FIG. 7

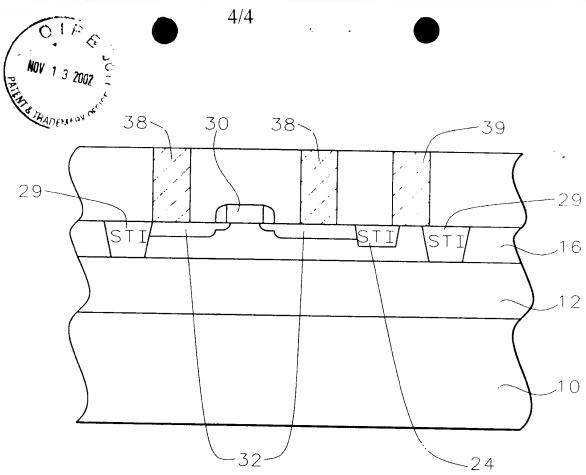
The Specification has been amended to correct an error wherein the shallow trench is referred to as 23 in Fig. 7.

The shallow trench in Fig. 7 is labeled 24.

Contact openings are etched through the ILD layer 36 to the underlying source/drain regions 32. At the same time, a contact opening is etched through the ILD layer 36 to contact portions of both the shallow trench [23] 24 and a nearby deep trench 29.
